RE: Rich Pit, M-1985-218, Technical Revision (TR-2), Mine Plan and Reclamation Plan Update

Martin Marietta Materials, Inc. ("Martin Marietta") submits this Technical Revision to Permit M-1985-218 to update the mining and reclamation plan to reflect mining of most of the Phase II area of 56.7 acres that was approved in TR-1 on December 14, 2023 and allow the Division to adjust the reclamation bond, if needed.

Exhibit C - Mining Plan Map
Rich Pit - M-1985-218
Pueblo County, Colorado

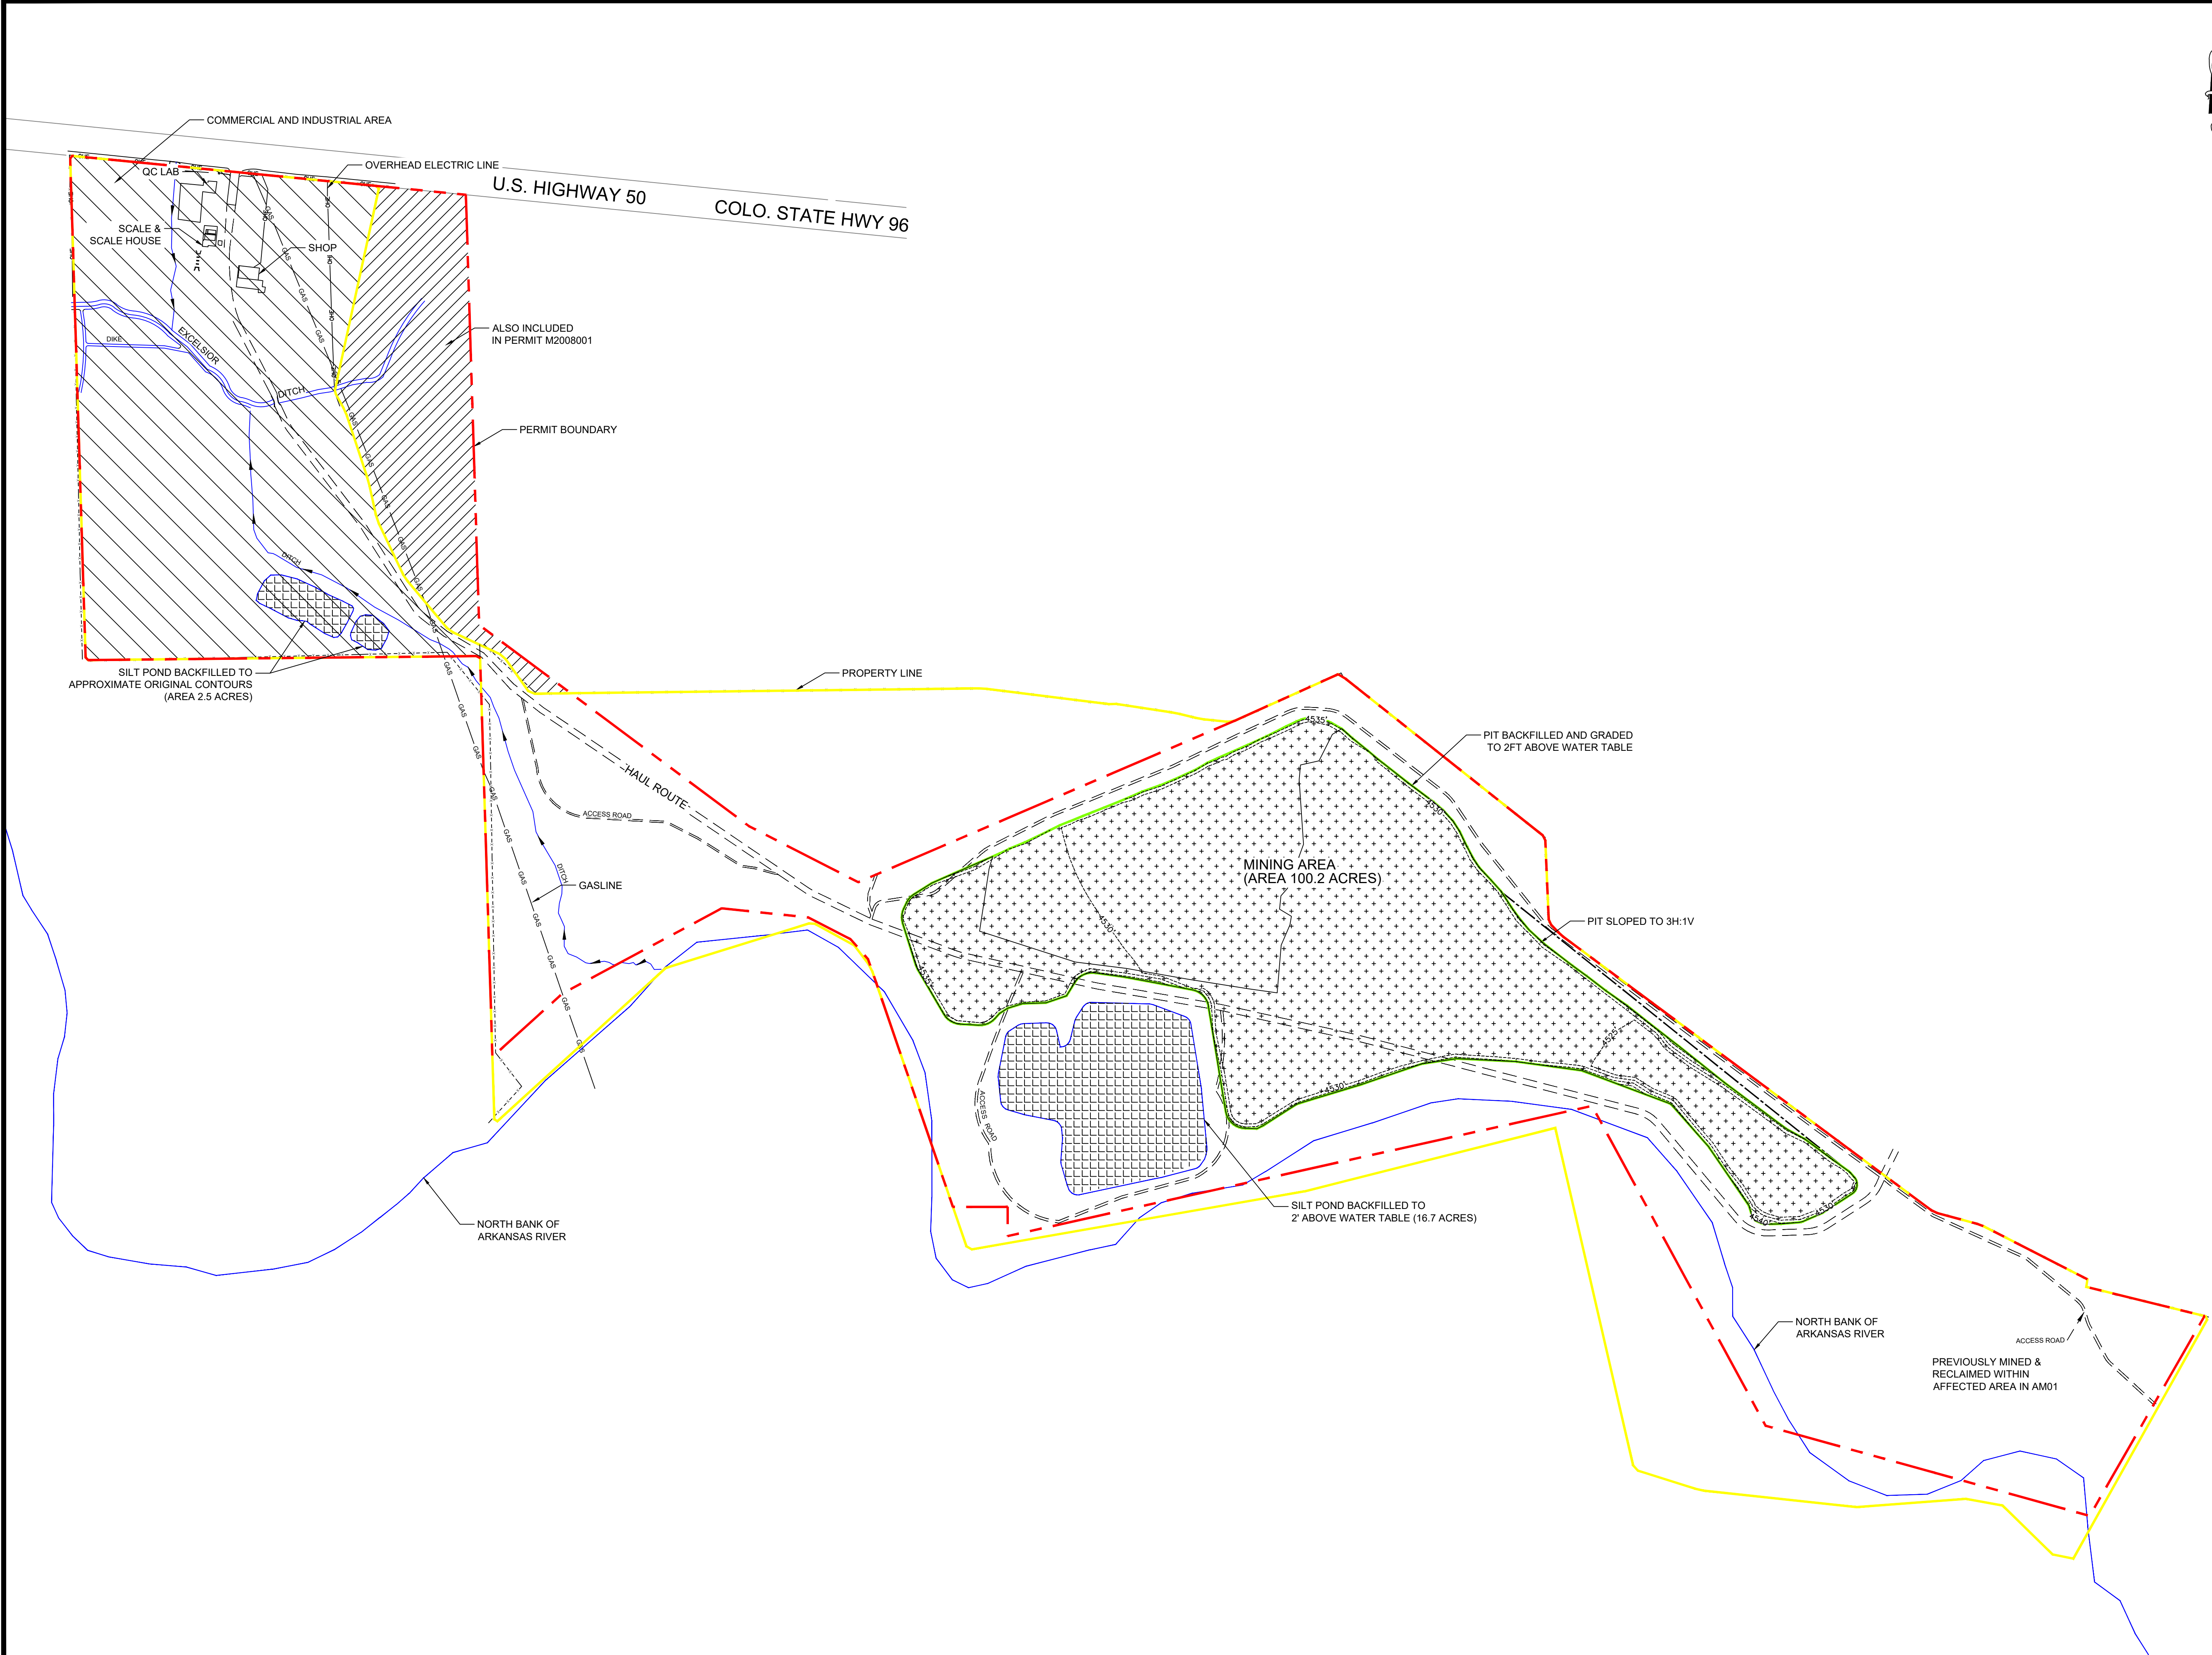
Exhibit C: Mining Plan Map

Mining will be accomplished within the 282-acre Affected Area per the previously approved mining plan at AM 01, Exhibit D. Enclosed Exhibits C and F show that mining will occur take place in 100.2 acres, which includes 54.6 acres included as Phase I in TR-1 and 45.6 acres that were shown as Phase II in TR-1.

Other areas within the Affected Area may still be used for interim uses such as overburden storage, silt storage, material hauling, and fresh water resources associated with the mineral extraction area as shown on the attached Exhibits.

Exhibit F
Reclamation Map - Rich Pit
M-1985-218 Pueblo County, Colorado

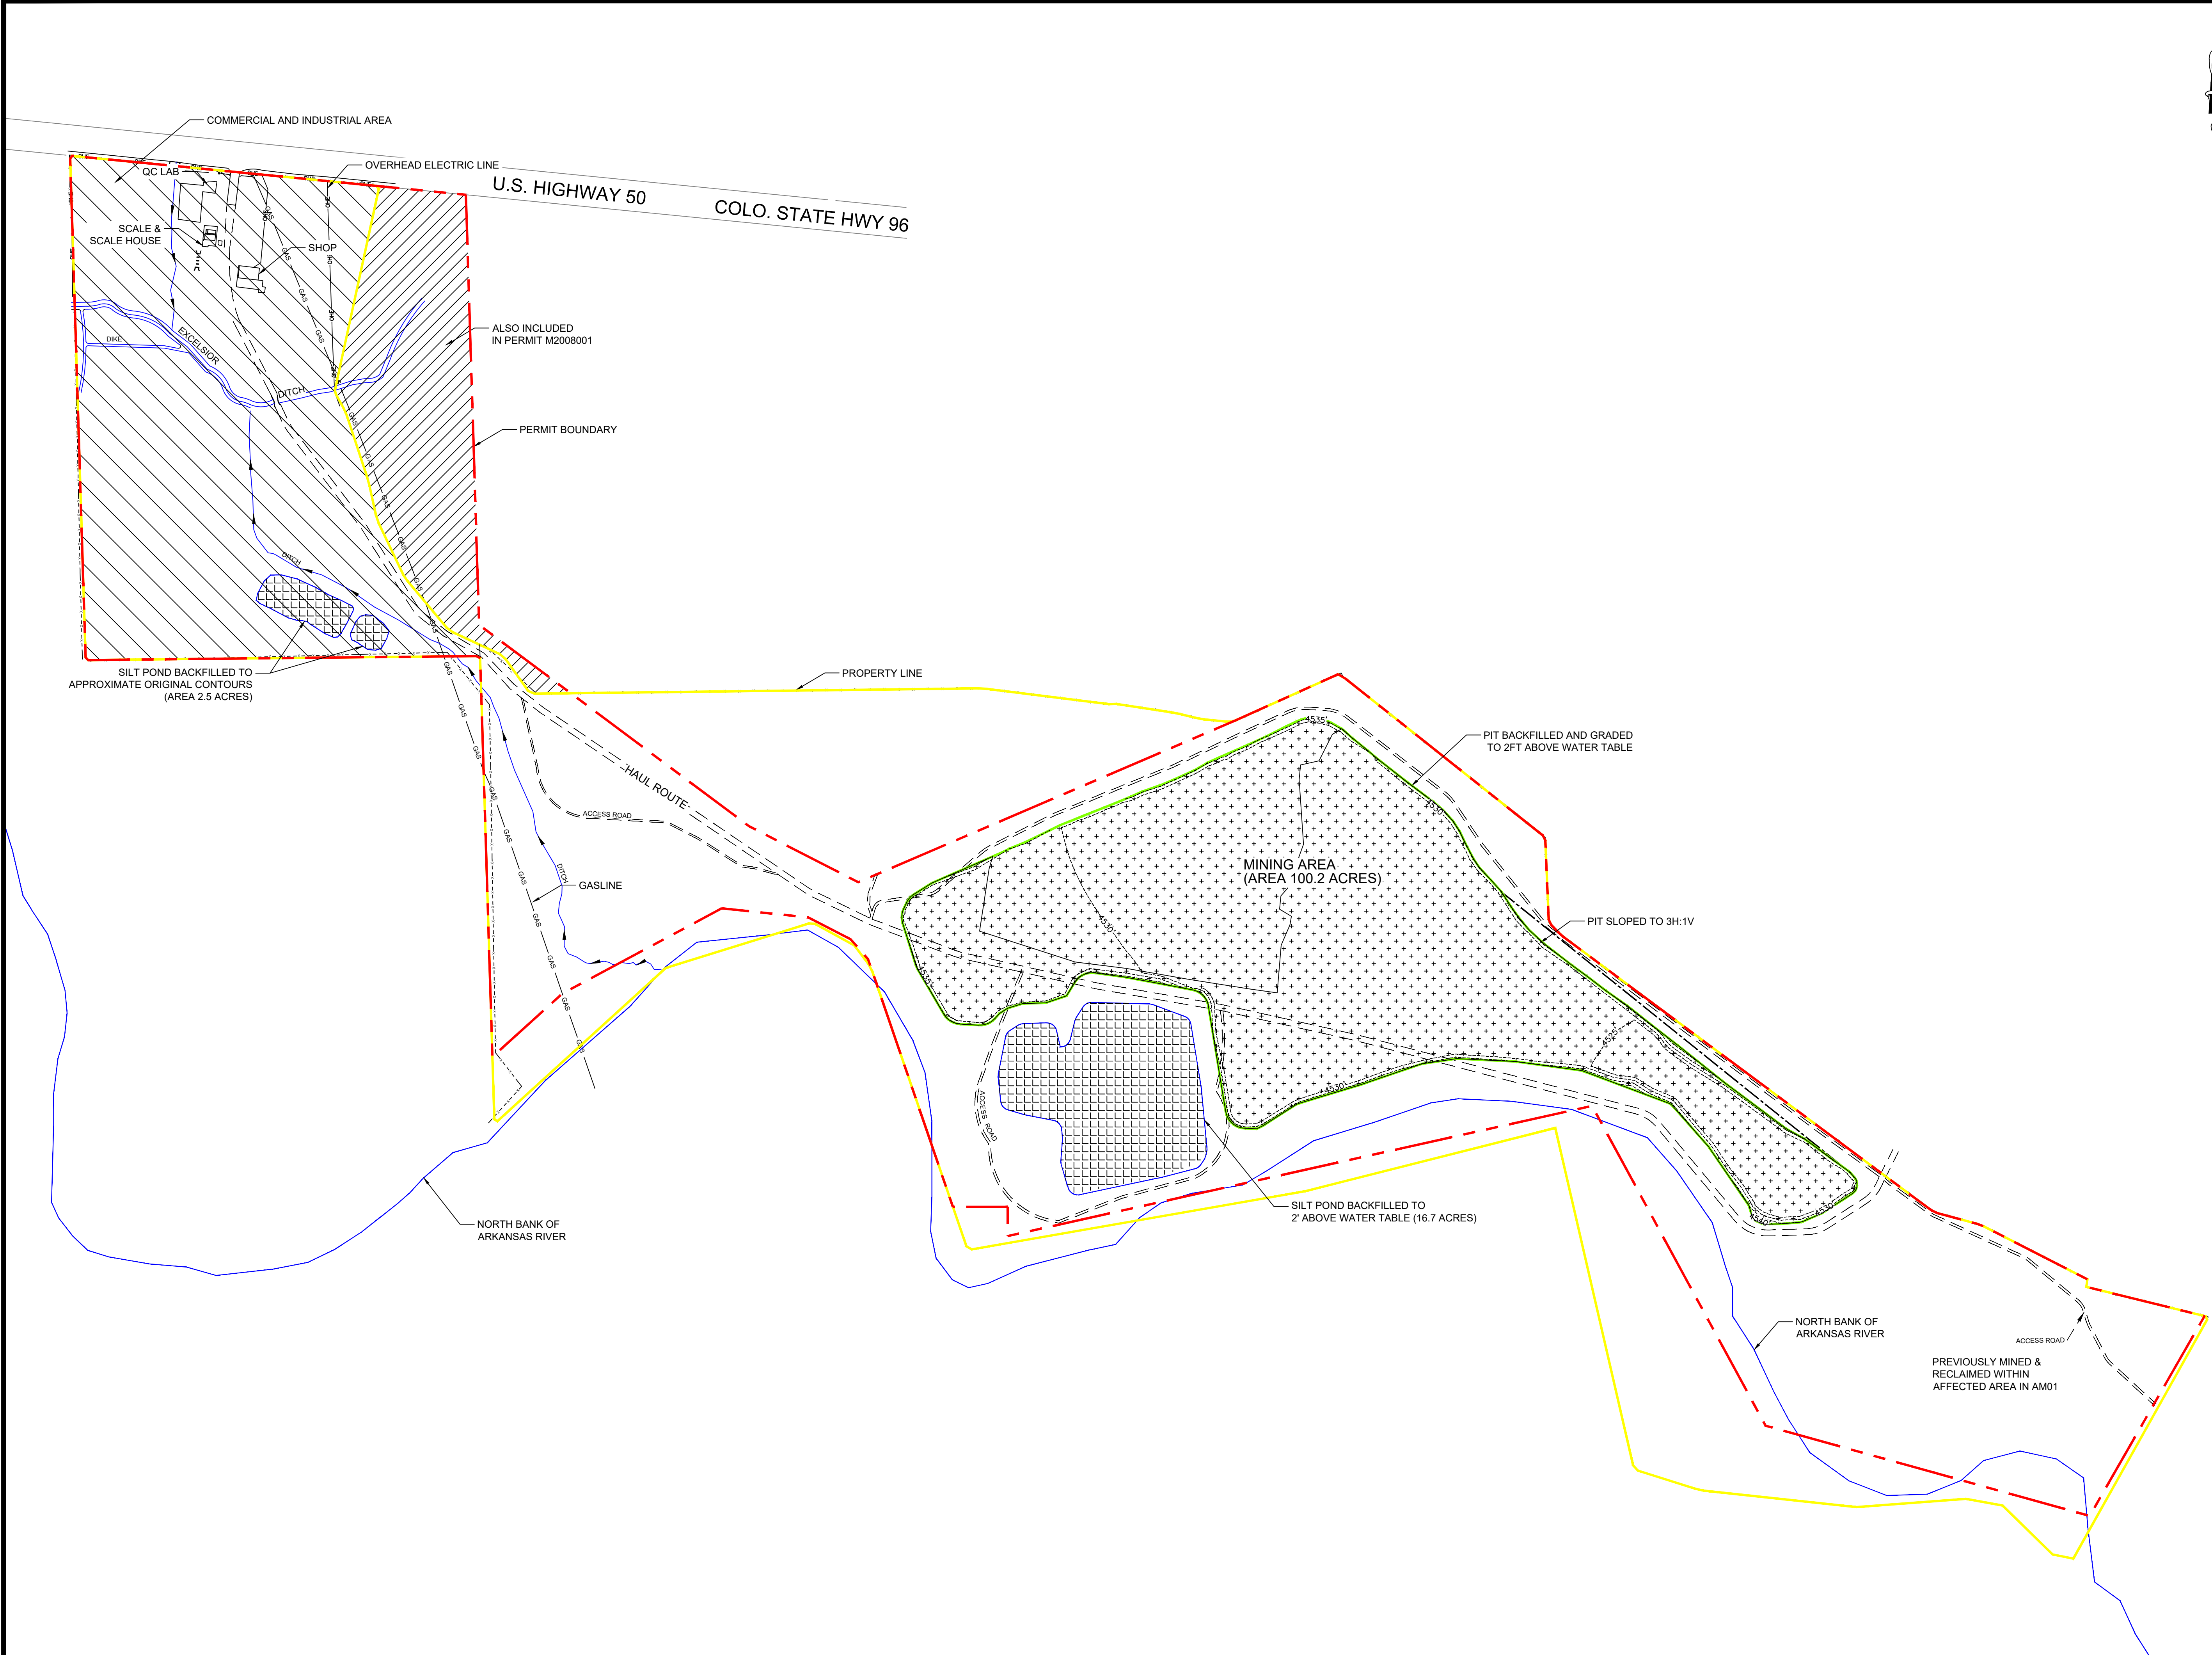
Exhibit F: Reclamation Plan Map

The mining area will be reclaimed as wildlife habitat and the Plant Site will be reclaimed as commercial/industrial area per the approved Reclamation Plan in AM 01, Exhibit E. For your information in calculating the bond, the mining area will be reclaimed by backfilling to an elevation that is 2 feet above the groundwater level. This will require 2,476,110 cubic yards of backfill material. The backfill will include overburden and waste material removed from the mining area.

The total available volume of material for backfilling includes:

- 889,460 cubic yards of overburden and waste that is either temporarily stored or still to be removed from mining area.
- 1,586,650 cubic yards to be brought in from owned neighboring property.
